# **Accessibility Assessment Report**

## **Bungendore Temporary School**

Report Number: RE230468.02Access

The purpose of this Access report is for completing an assessment of Schematic Design Stage architectural drawings associated with the proposed Bungendore temporary high school located at 10 Majara St, Bungendore NSW.

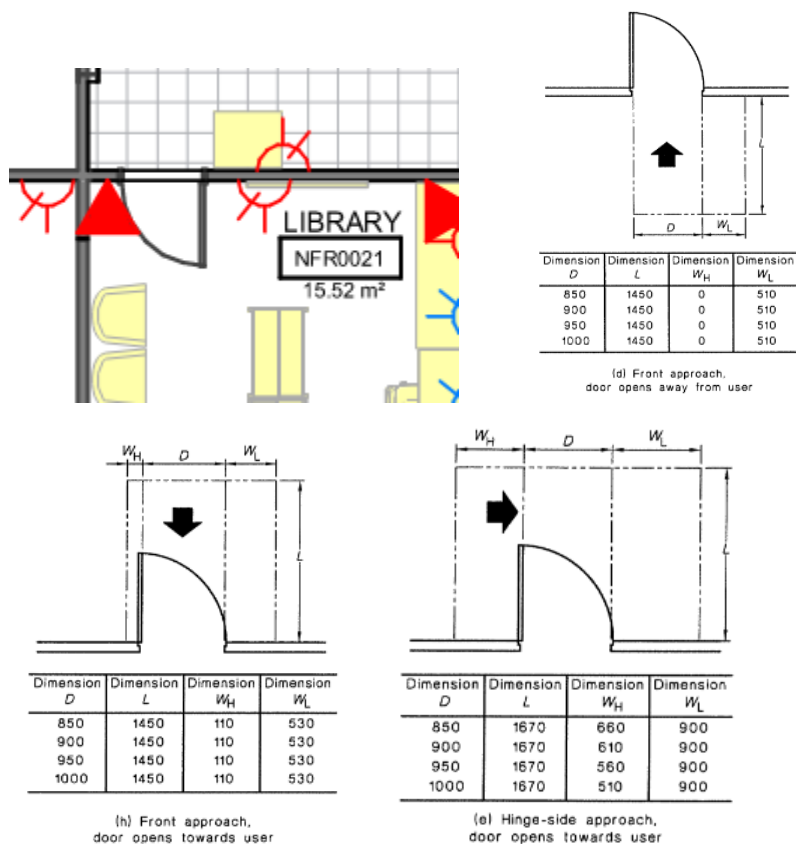
- (b) Not all existing doorways provide a clear width of minimum 850 mm (in the case of double door, measured at the active door leaf). An upgrade to comply is required.

(d) Some door controls in the existing building affected part do not comply with Clause 13.5 of AS 1428.1-2009. An upgrade to comply is required.

Provide design detailing demonstrating compliance at the appropriate future design stage.

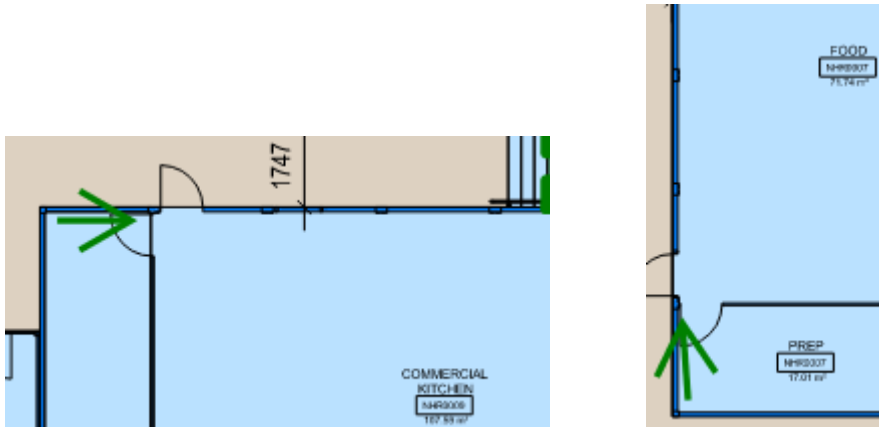
9. The door to the food prep room and commercial kitchen store do not have the required 110 mm hinge side clearance. Minor design change required.

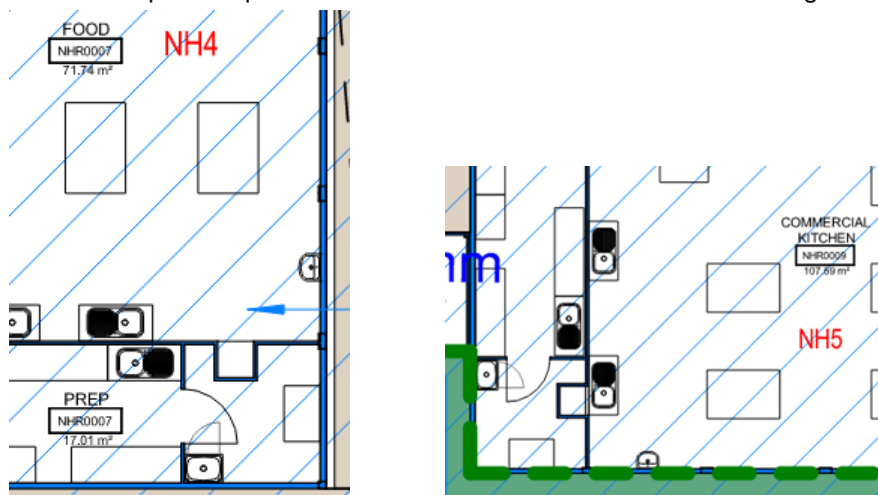
10. The door (x2) between the food prep and laundry does not have the doorway circulation space requirements on both sides of the door. Minor design change required.

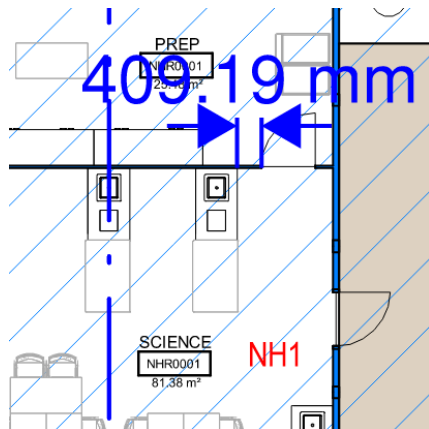
11. The fixed work bench on the Science room is to be relocated so that it is at least 530 mm from the latch side of the doorway.

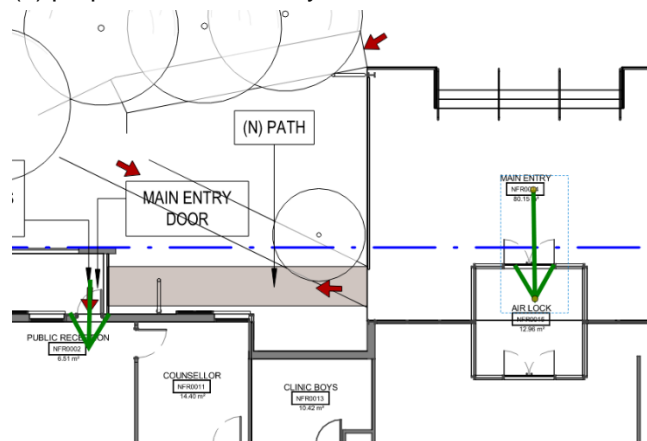
2. One existing accessible car space is available at the front. The path of travel from the car space to the main building entry is existing except for the adjusted path referred to above. The existing car space does not fully comply with current standards, however there is no statutory requirement to upgrade.

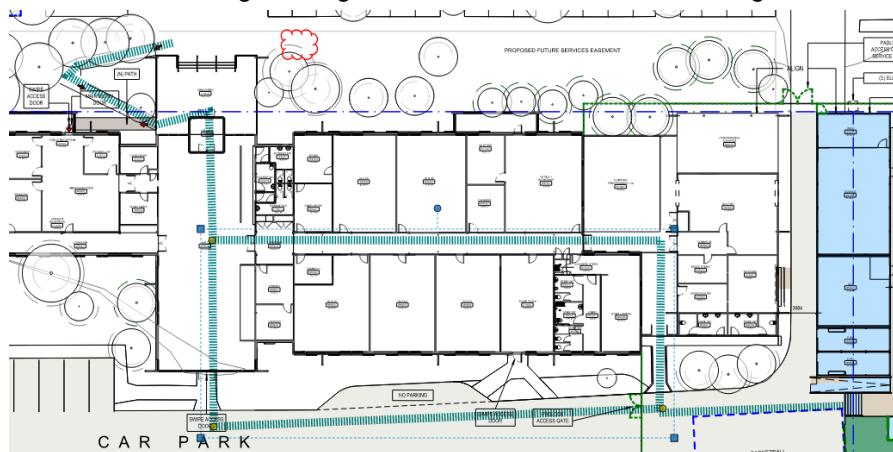
The main school entry does not fully comply with AS 14281.1 as follows:

- (i) The existing entry stair do not have contrasting nosing required by Clause 11.1((f)&(g) of AS1428.1. An upgrade to comply is required. The treatment must also be selected to achieve a slip rating of no less than P4.

- (ii) The door hardware consisting of snib lock does not comply with the door control requirements of Clause 13.5 of AS1428.1. An upgrade is required to comply.

- (iii) The visual indicators on the door and adjoining glazing does not comply with Clause 6.6 of AS1428.1. An upgrade is required to comply.

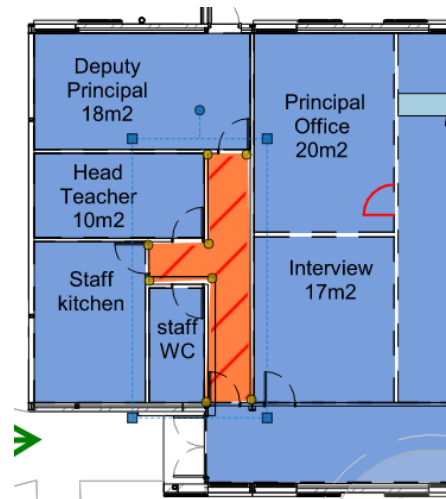
5. The existing building generally complies with passing space and turning space requirements except for the existing corridor serving the Deputy Principal office, Head teacher office and staff kitchen. As there is no physical building work\* in this area, there is no statutory requirement to upgrade compliance.

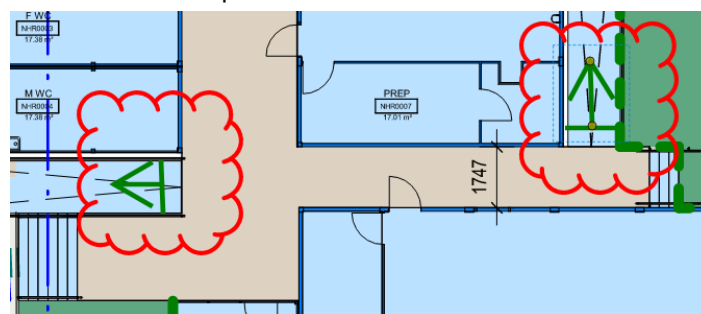
7. The proposed stairs to the new building are to be designed to comply with AS1428.1. Compliance generally indicated and readily achievable subject to design detailing at the appropriate future design stage.

8. The proposed ramp is to be designed to comply with AS 1428.1 Compliance generally indicated and readily achievable subject to design detailing at the appropriate future design stage. Particular attention is required to grade, handrail extensions and tactile indicators, which are not currently shown on the plans. Further, the ramps are to be set back from the main circulation deck to ensure that the handrail extensions do not protrude into the transvers path of travel.
